## *Technical Bulletin 92*

### Fairchild Actuator Hardware Modification

Version 1.0, Revision AC (5 February, 2004)

**Image of additional diode (D4) Added to produce the Fairchild Revision F electronic board.**

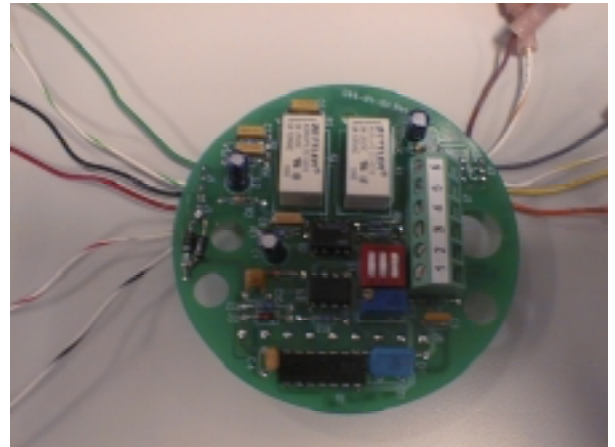
Unfortunately the firmware feature did not resolve all full open/closed latching problems encountered. For this reason we asked Fairchild to produce a hardware change to their electronic board to resolve this situation. All actuators with revision “PA” or later should have the new electronic board (Part # 044-IPI-101-01 revision F or later) that corrects this problem.

Fairchild has agreed to modify electronic boards with the above symptoms. The modification requires the board be returned to Fairchild for hardware modifications. Fairchild will charge a \$40 fee for this modification. Customers may contact Fairchild directly or ABB-Totalflow for repair instructions. **This repair fee offering will expire on 4/15/2004! Repairs after this date will be at Fairchild’s standard repair rates. Contact Fairchild directly for pricing and shipping information.**
